SUBJECT: FORWARDS "PRESERVICE INSP PROGRAM PLAN, VOLS 1 & 2."

Subject: WPPSS NUCLEAR PROJECT NO. 2
PRESERVICE INSPECTION PROGRAM PLAN

**PRESERVICE INSPECTION
PROGRAM PLAN**

Figure 7

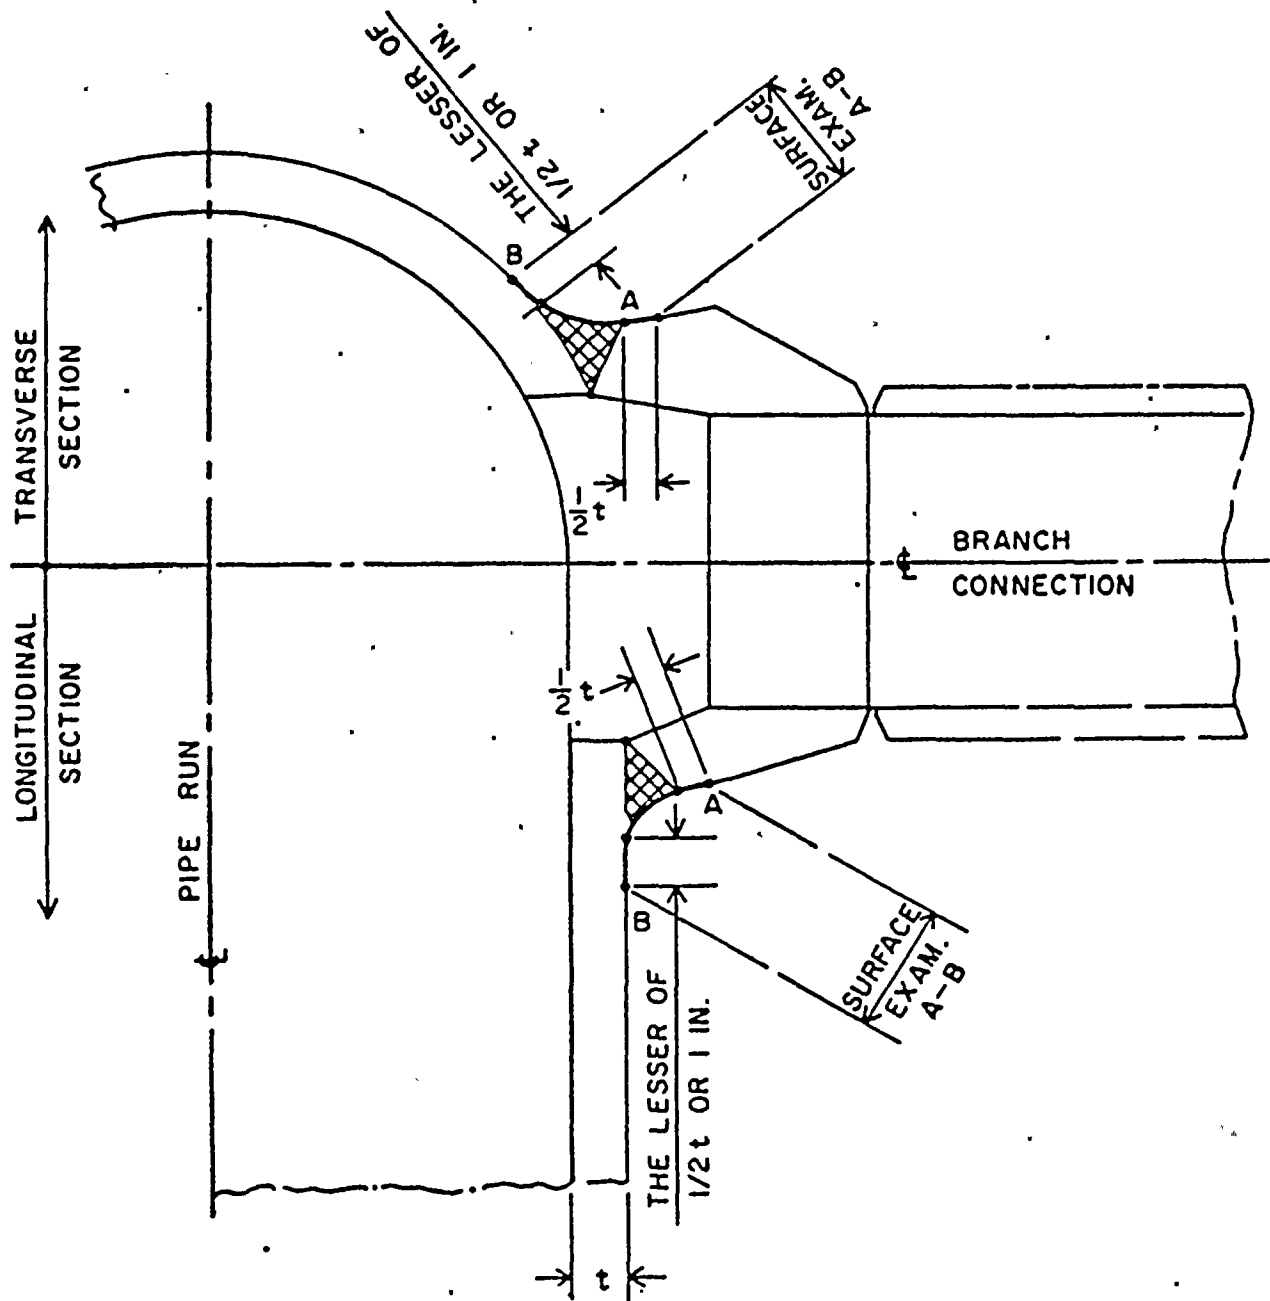
Fig 7 Change Austenitic to "Ferritic"

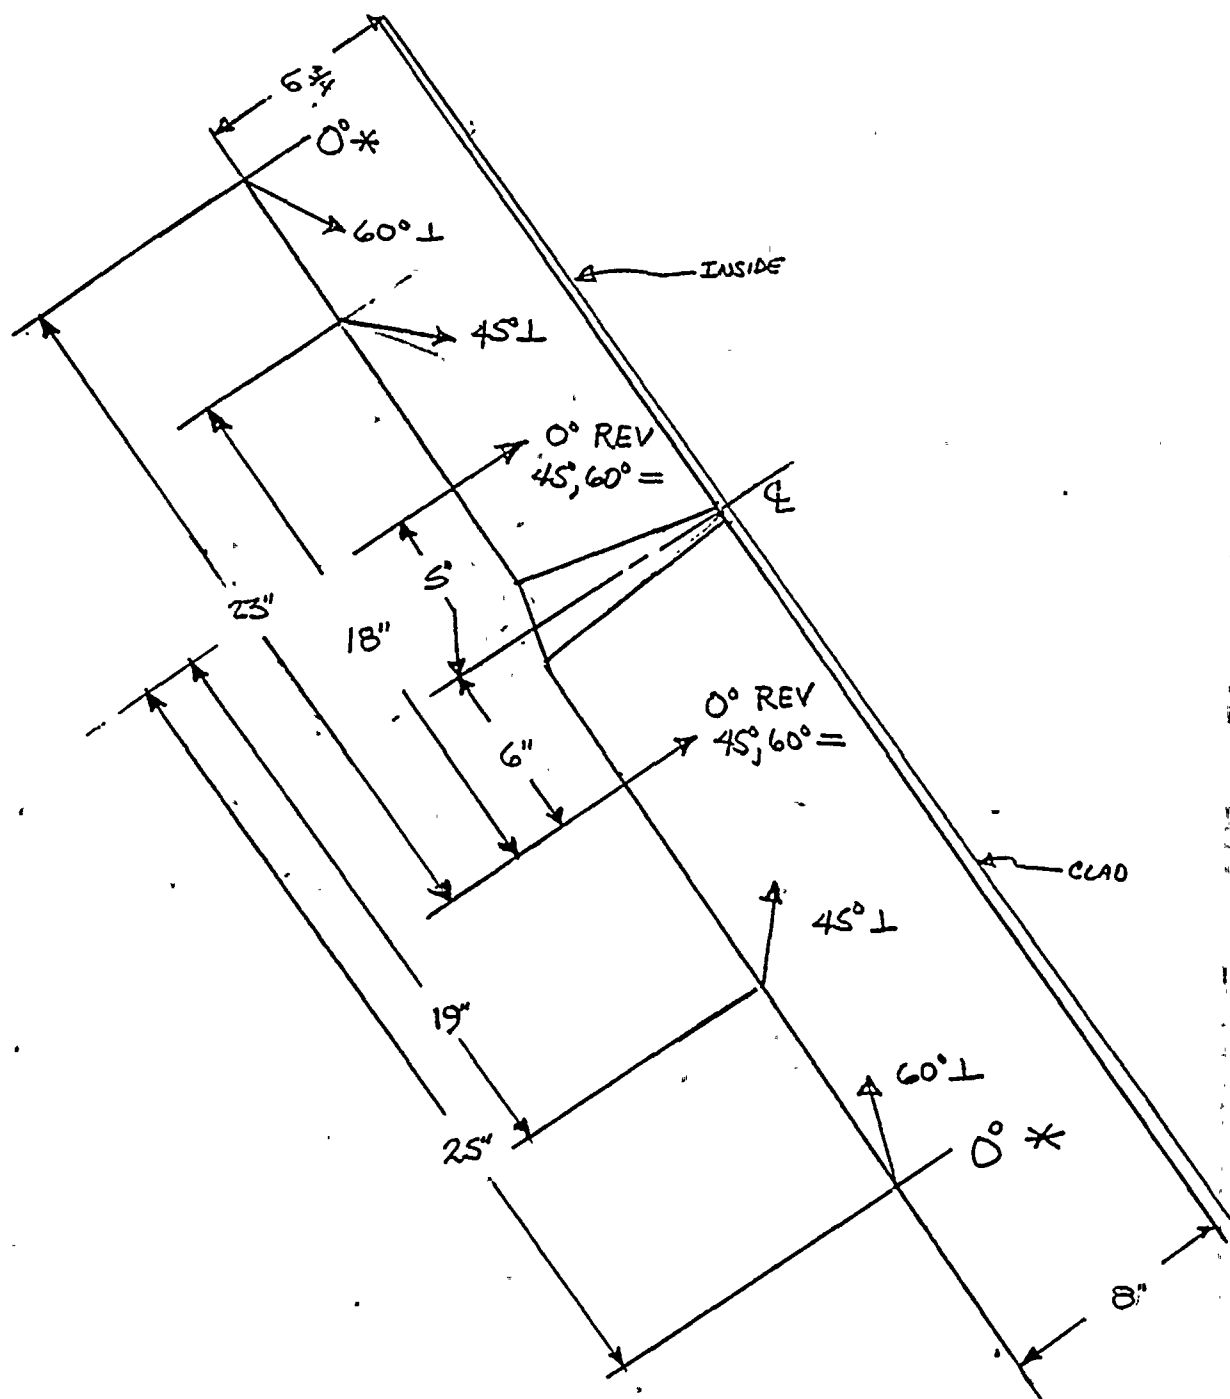
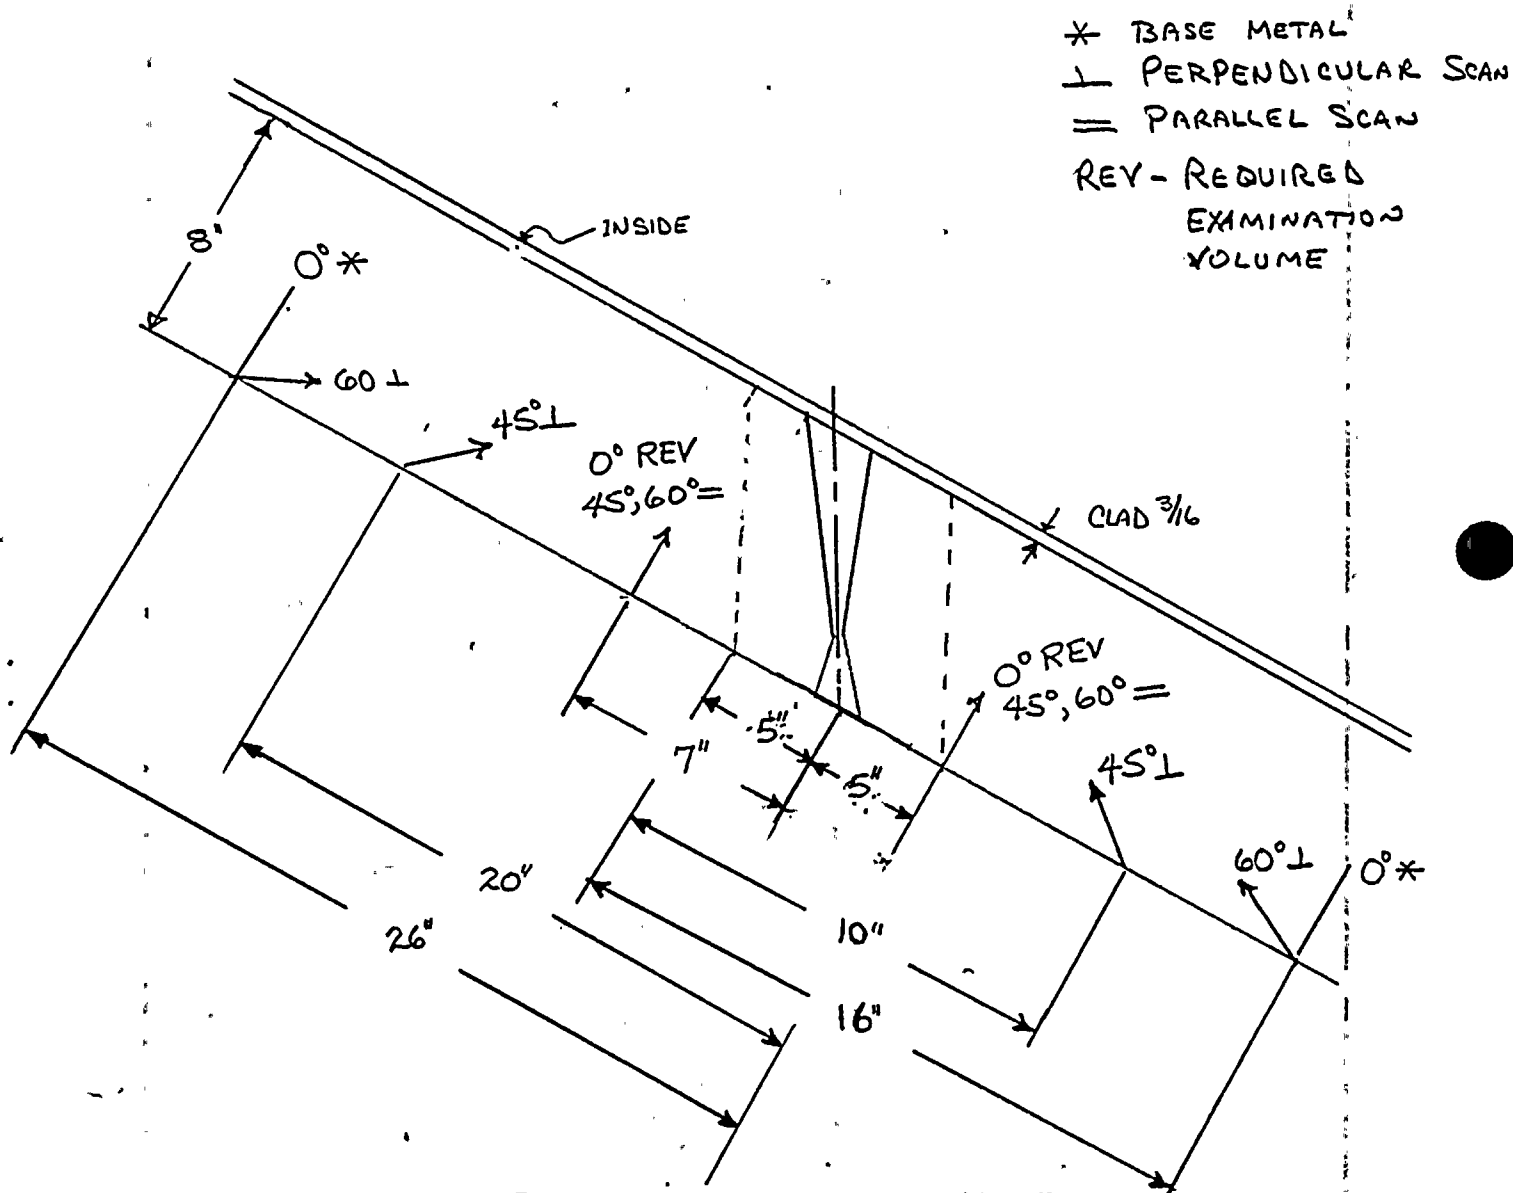
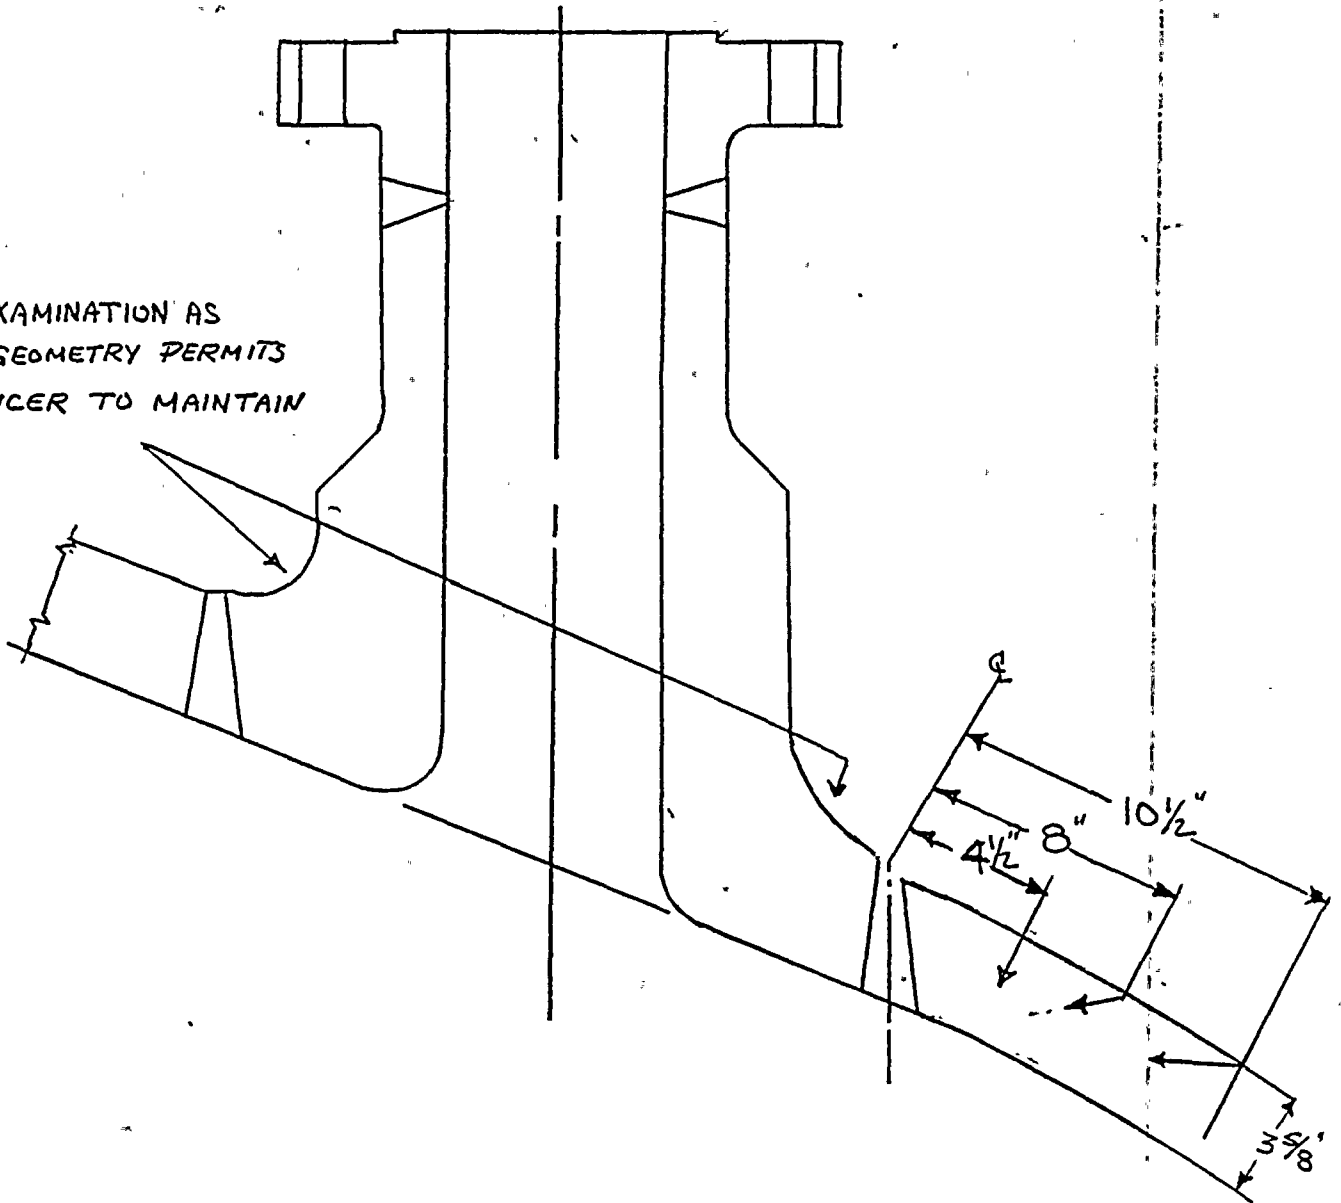
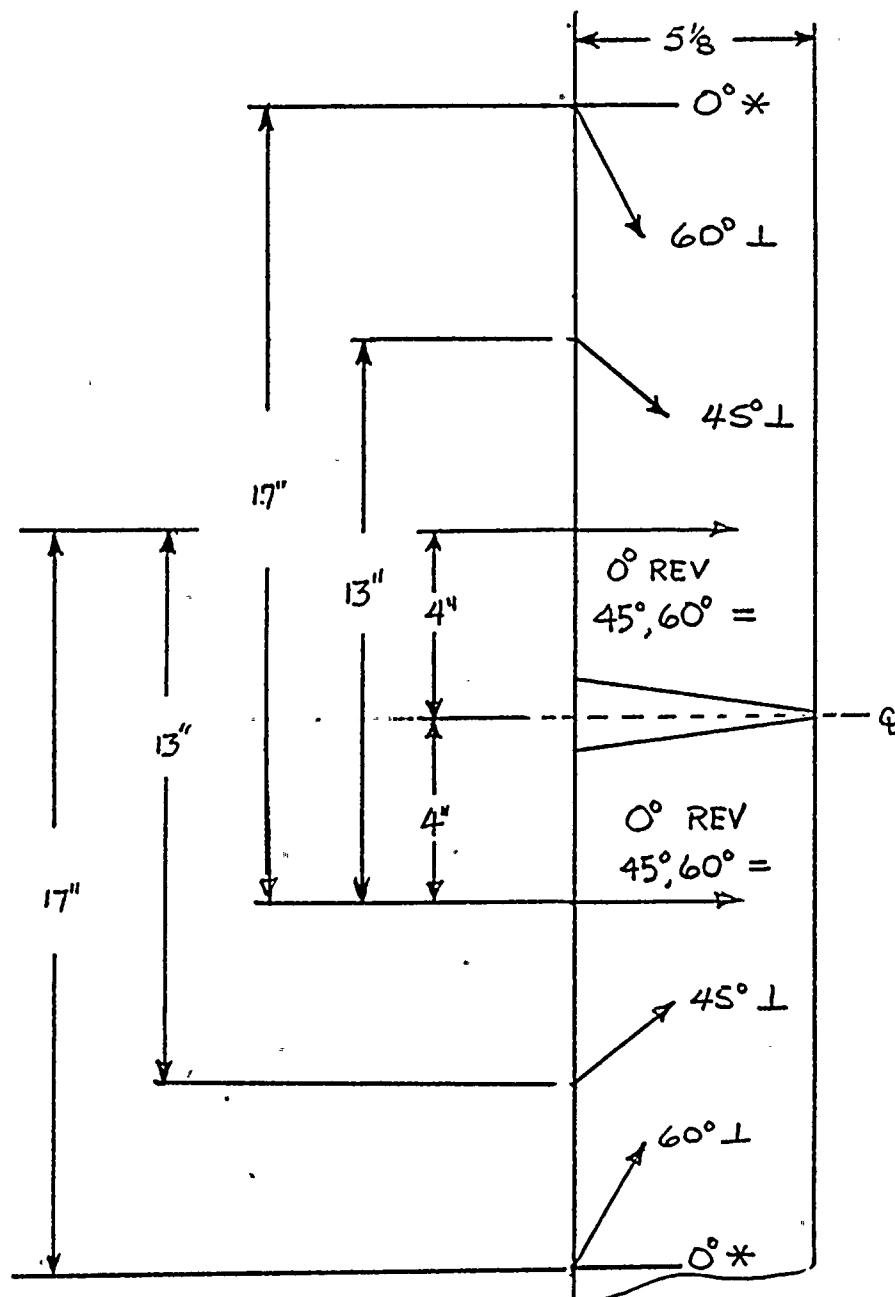
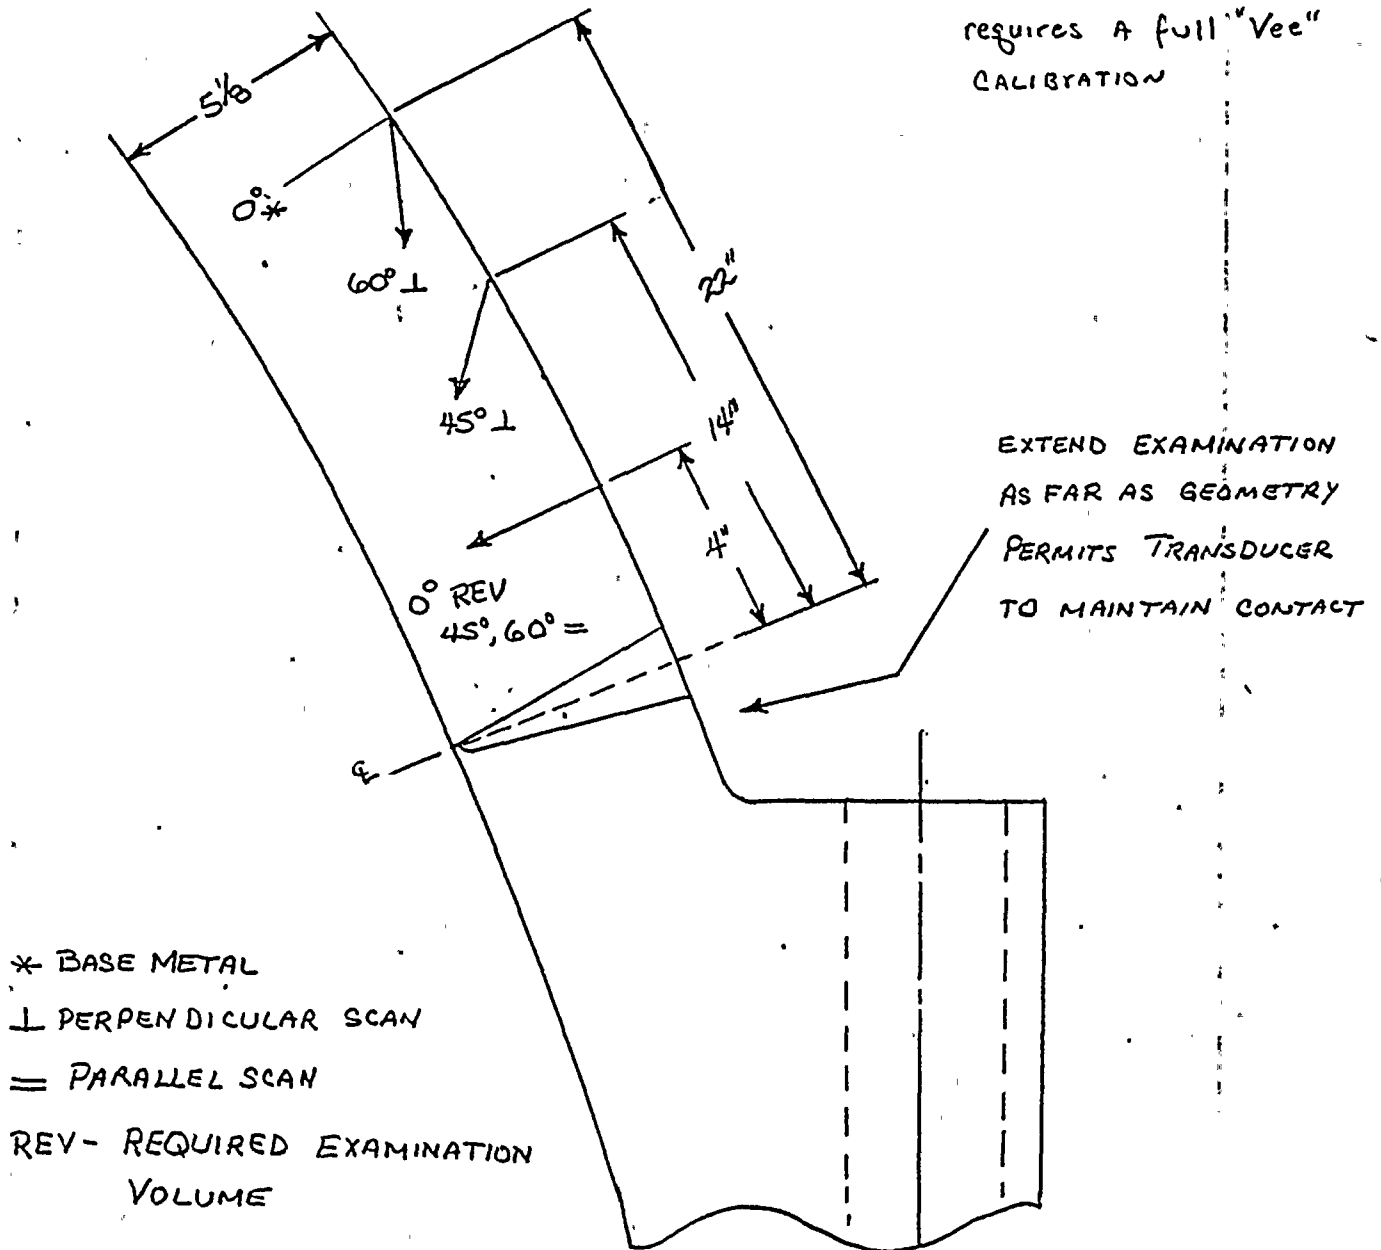
Add Figures 20A, 20B, 20C, 20D AND 20E^{20F} to procedures.
 these figures top and bottom head show weld coverage and should have
 been included in Rev 1.
